Technical Service BULLETIN

VACUUM HOSE PRODUCTION CHANGE

'98 RAV4

ENGINE
EG009-98

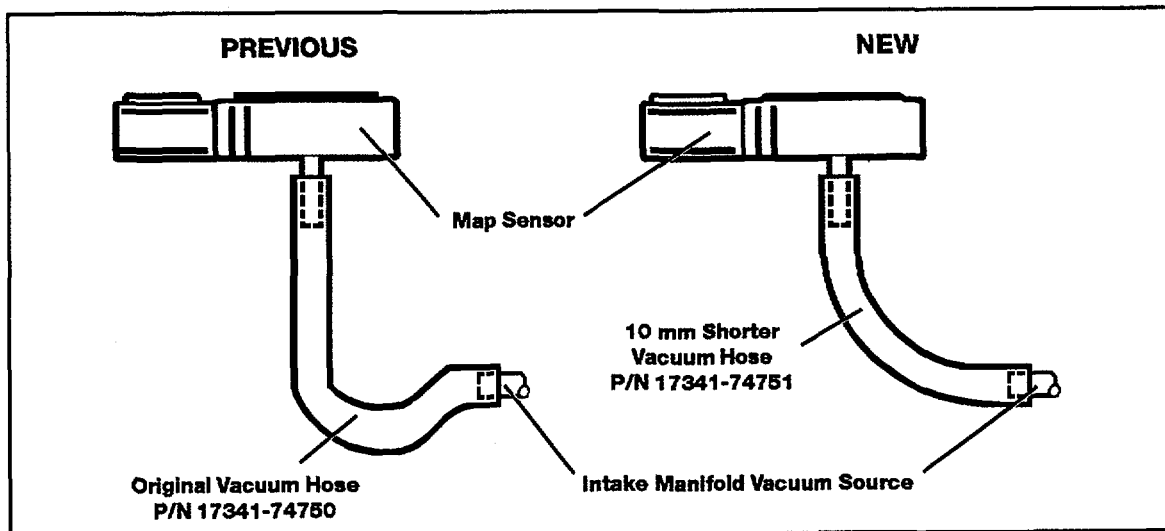
Introduction To minimize moisture retention and improve MAP Sensor operation, the length of the connecting vacuum line has been shortened 10 mm.

OLD PART NUMBER	NEW PART NUMBER	PART NAME
17341-74750	17341-74751	Hose, Vacuum
